DESIGN REVIEW - AVALON BALLARD

DPD Project No.: 3009098

DESIGN REVIEW BOARD RECOMMENDATIONS

VIEW FROM 14TH AVENUE NW LOOKING AT MAIN ENTRY

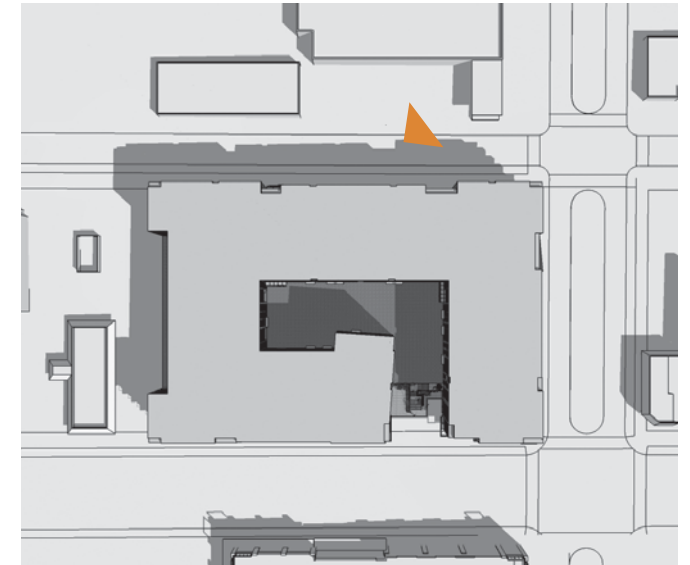
| 4 | <p>A-1: Responding To Site Characteristics: Cladding materials need to respond to location and provide a sense of scale.</p> | <p>Recommendation: The main building entrance could have masonry brought all the way down to street level rather than the wood-like material shown at the meeting.</p> | <p>Response: The glassy main residential entry is clad in dark textured porcelain tile and wood composite panel. These materials set this area apart from the building above and the adjacent retail. They are scaled appropriately to the pedestrian and the slower traffic along 14th Avenue NW.</p> |

VIEW FROM NW 56TH STREET LOOKING WEST AT STOOPS

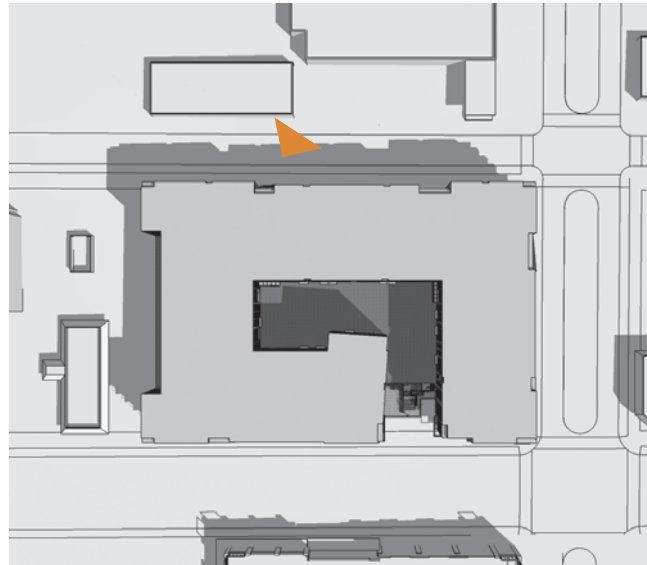
| 1 | <p>EDG#2 Issue: The design and function of the porch entries to the units at the street level along N.W. 56th Street.</p> | <p>Recommendation: Some members of The Board liked the three part division of the façade at the base; however, the group asked the applicant to look into continuing the stoops into the western third of the façade.</p> | <p>Response: In response to The Board's request, the residential entry was enhanced with additional planting areas and an entry stoop was added to the west. The cascading planters were also expanded to compliment the pedestrian environment of the stoop entries to the east.</p> |

VIEW FROM NW 56TH STREET LOOKING AT SECONDARY ENTRY

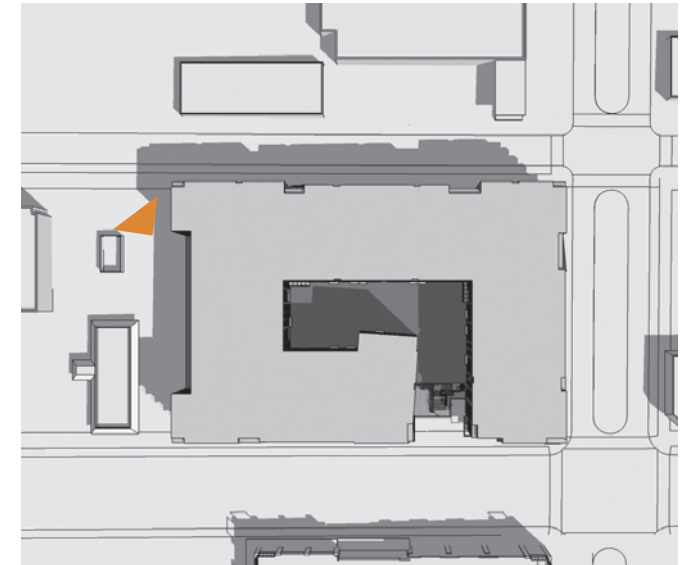
| 3 | <p>EDG#2 Issue: The composition and design of the north façade of the building along N.W. 56th St. including measures to control its appearance of bulk and scale.</p> | <p>Recommendation: The residential entry on N.W. 56th does not look very residential. An effort to create a residential presence in the ground plane with transparency elements greater than six feet in height should be undertaken</p> | <p>Response: The NW 56th Street entry is marked by a prominent canopy, gracious stairs, cascading planters and full-width and full-height storefront glazing inviting future residents to use this access.</p> |
| 6 | <p>A-4: Human Activity: Revise site circulation patterns</p> | <p>Recommendation: Improve the connection to the private courtyard</p> | <p>Response: The interior circulation patterns have been redesigned to give direct visual and physical access between the NW 56th Street entry and the internal courtyard</p> |

VIEW FROM WEST LOOKING AT NW MARKET STREET

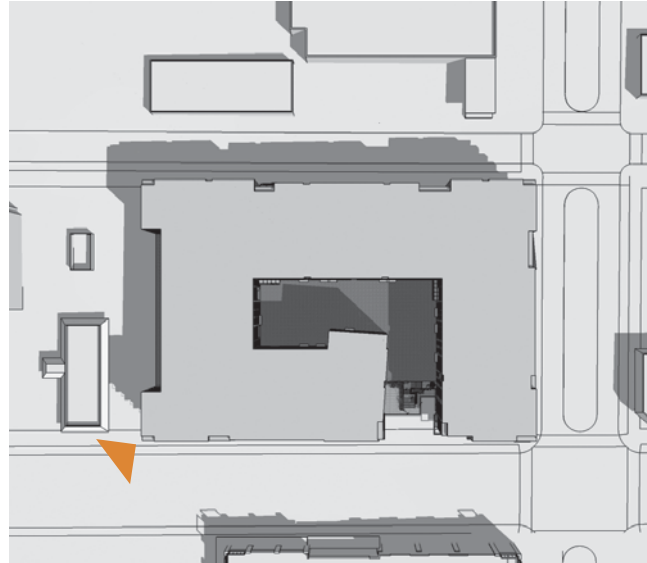
| 2 | <p>EDG#2 Issue: The design of the west façade which is close to the property line, has the potential for large blank facades and is likely to be visible for the foreseeable future, until the adjacent site is developed.</p> | <p>Recommendation: The west façade elevation is found to be highly successful. One additional design measure should be to incorporate some patterning into the two end walls</p> | <p>Response: The west property line façade provides a visually interesting pattern of color in response to the speed of traffic and scale of NW Market Street. The central portion of the west façade is pushed back at grade to allow for dense vertical plantings covering the adjacent wall.</p> |

VIEW FROM NW MARKET STREET LOOKING AT RETAIL

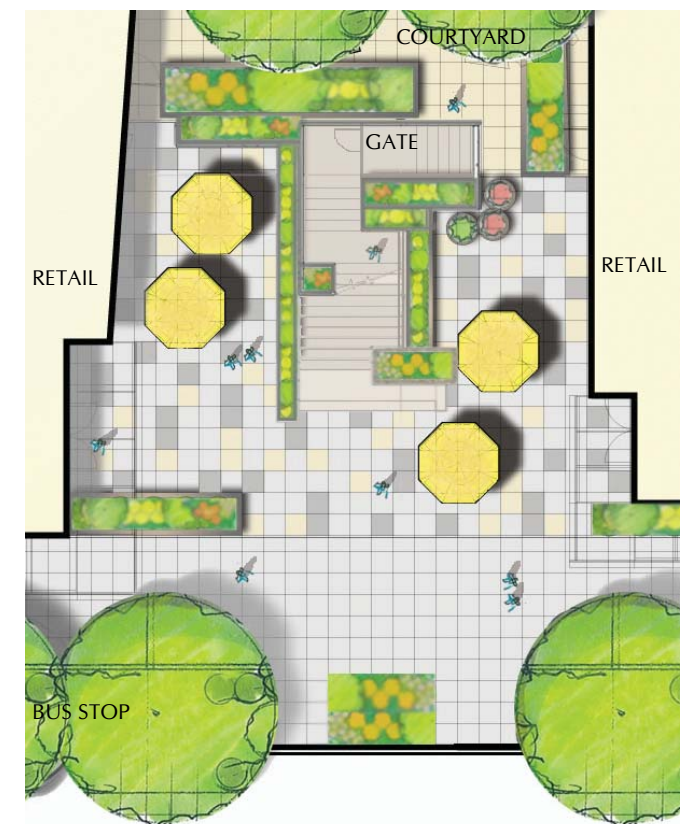
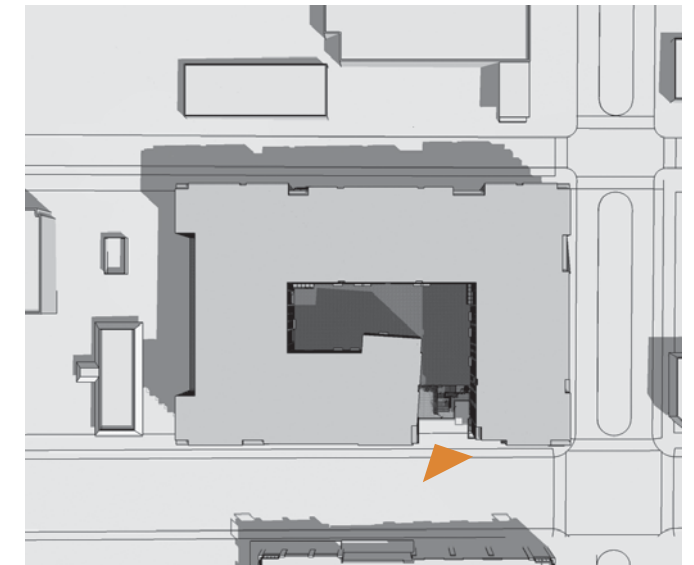
| 5 | | <p>Recommendation: The promised "fine grain" of storefronts should rely on existing storefronts in the Ballard area for inspiration. Something of better texture and finish than painted concrete should be used for the building base around the commercial uses.</p> | <p>Response: The contemporary storefronts are clad in large panels of dark porcelain tile. The retail signage, canopies and lighting all combine to give the commercial frontage an intimate scale.</p> |
